Camden Residents' Action Group Incorporated Camden – Still a Country Town

Re: DA 2023/36/1

35 Menangle Road, Camden

Demolition of existing dwelling and construction of a new two storey dwelling with swimming pool and landscape works.

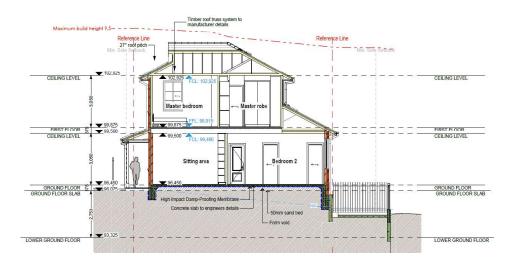
As is evident in the top drawing the roofline at the eastern top ridgeline is not consistent with the HCA roofscape, and presents as a jarring note. The odd roof form would seem to be the result of the additional possibly unnecessary roof space shown in second drawing above. A character element of the HCA is its unique roofscape (DCP 2.16.4), and as such the roof form of the design should be similar to and sympathetic with it.

Source: Urban Revolutions 1 June 2023 Amended Architectural Plans West Elevation

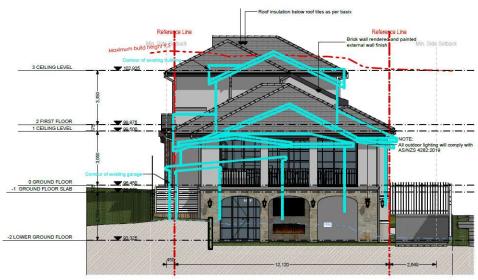
As shown in the above architectural drawing the proposed building is over the height standard of 9.5m. The exceedance would appear to be greater than 10%. No s4.6 variation has been included with the DA, which indicates that the documentation for exhibition of this DA is incomplete.

It is problematic also that the building presents as a three-storey construction from some perspectives. A DCP control for the HCA (2.16.4 (9)) is that a two- storey height limit must prevail.

It is also apparent from the above architectural drawing that the side setback from Macarthur Park is less than the minimum setback of 0.900m. This setback is not a minimum of 1.350m as claimed in the SEE (Table 2, p. 15). As the Macarthur Park side of the proposed new build is the main pedestrian entrance this setback should be greater, more in keeping with the large scale of the proposed house. It is also appropriate and expected to have a much greater separation between a private residence and the public domain of the Park.

Source: Urban Revolutions 1 June 2023 Amended Architectural Plans

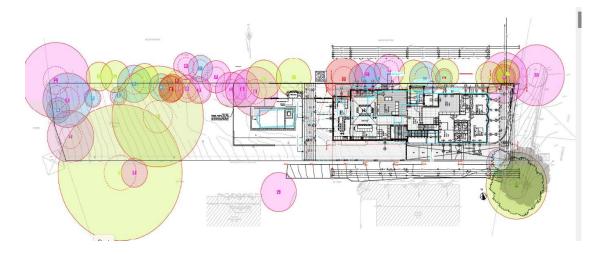
However, the Architectural Plans show trees in adjacent Macarthur Park, and encroachment into their tree protection zones. The diagram below shows Macarthur Park to the top, and the Google Earth image shows Macarthur Park to the left. It is clear that very mature trees in Macarthur Park

The proposed new build encroaches into the tree protection and structural root zones of trees in Macarthur Park. SEE 5.1.1, as quoted above, suggests that the Proponent sees no necessary requirement to protect the trees in the Park. It would seem that the proposal is deeming which trees are expendable and not taking responsibility for ensuring no damage to the historic community asset.
